Proposed amendment to ECE Regulation 13

The text reproduced below was prepared by the experts of the informal working group ACV for the amendment of Regulation No. 13. This is to enable the use of automatic couplings systems.

Annex 22

REQUIREMENTS FOR THE BRAKE ELECTRIC/ELECTRONIC INTERFACE

Figure A: Point-to-point connection ECU Tractor (E1) and ECU Trailer (E10) via ACV

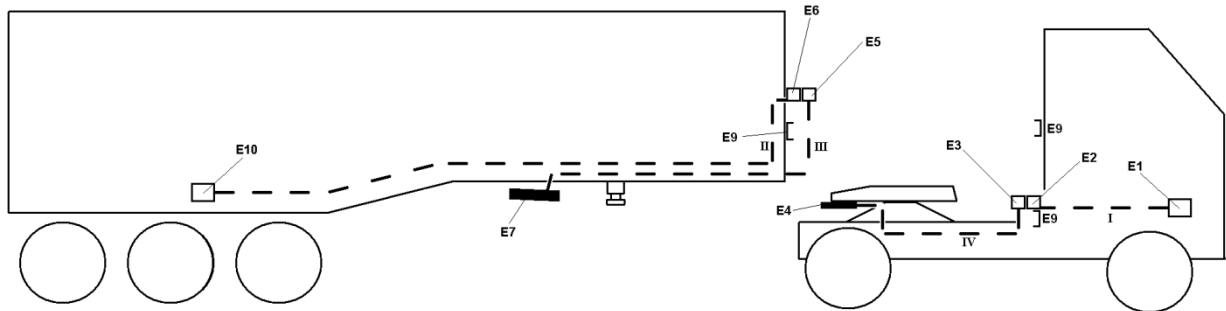
Automated connection mode: No coiled cables connected, Connection between E1 and E10 when E4 and E7 are connected (i.e. when fifth wheel coupled)

Figure B: Point-to-point connection ECU Tractor (E1) and ECU Trailer (E10) via coiled cable

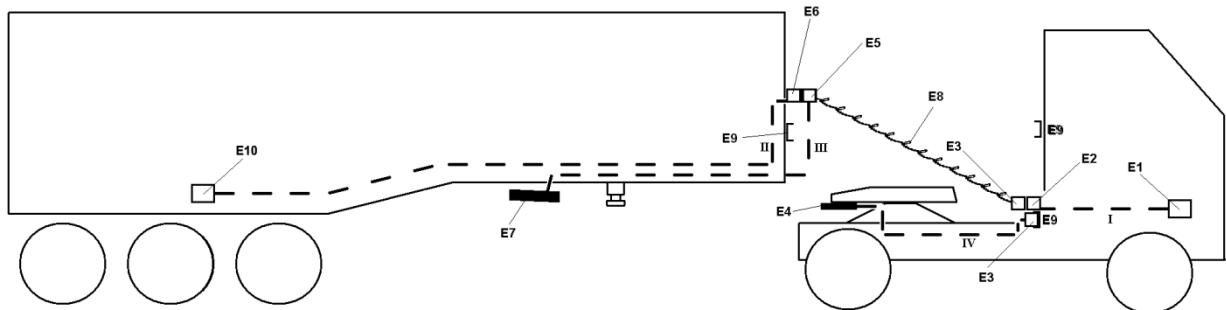
Manual mode: Coiled cables connected, Connection between E3 and E4 as E5 and E7 are not in use

Figure C: Point-to-point connection ECU Tractor (E1) and ECU Trailer (E10) when Fifth Wheel is closed

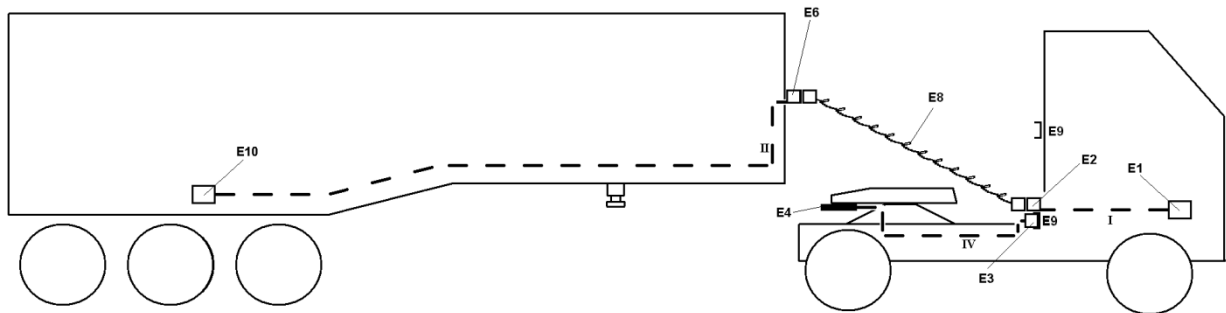
Coiled cables connected, Line E3 to E4 is not in use

Figure D: Point-to-point connection ECU Tractor (E1) and ECU Trailer (E10)

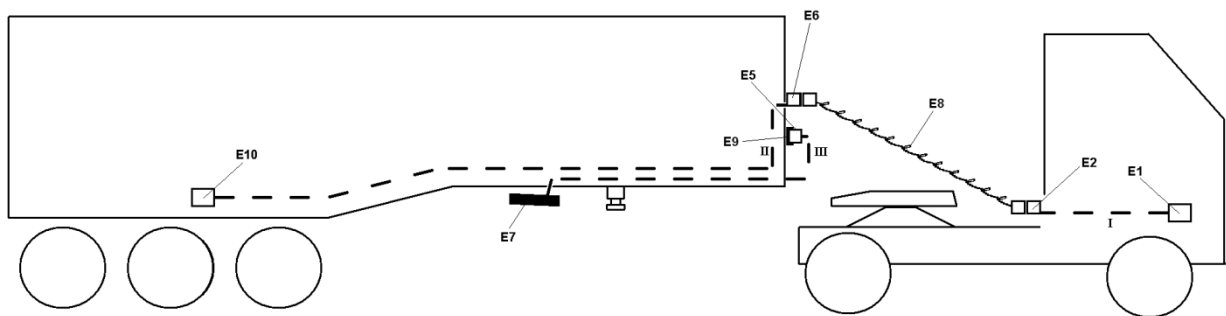
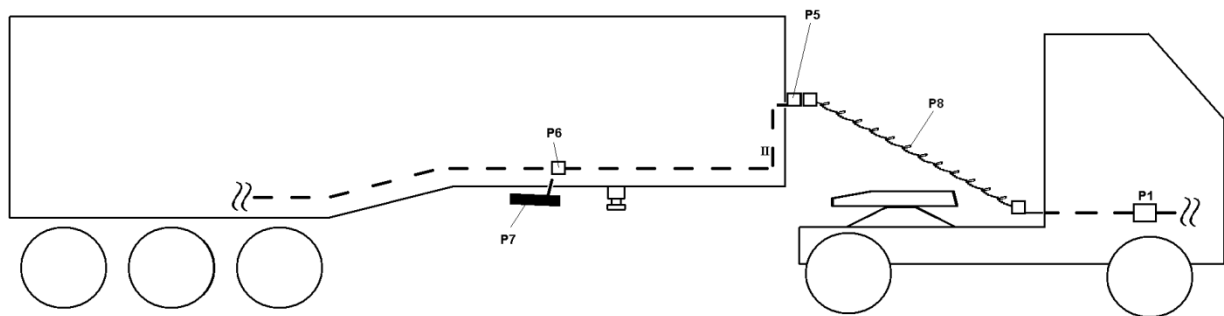
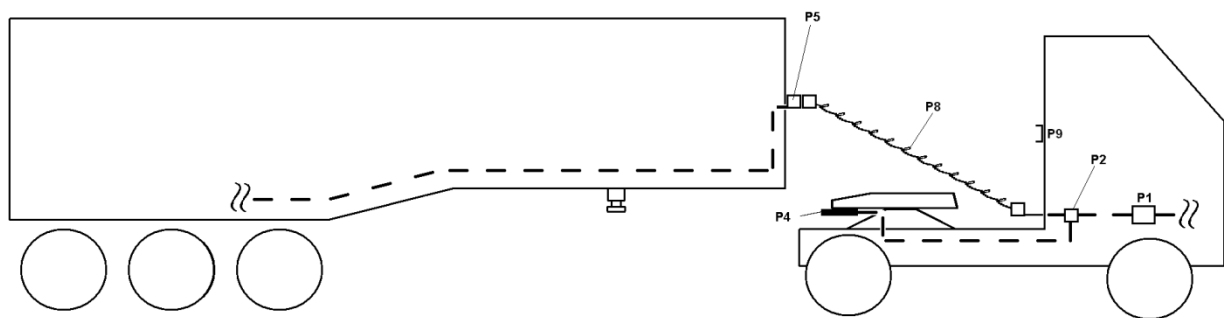
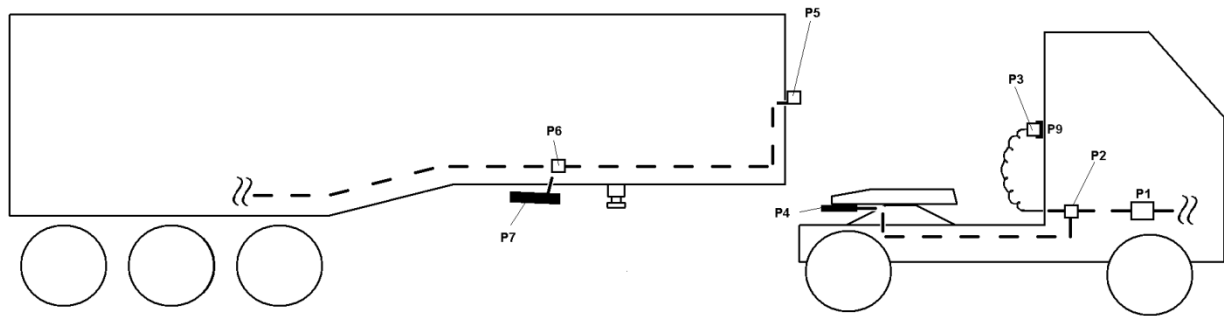
Coiled cables connected, Line E5 to E7 is not in use
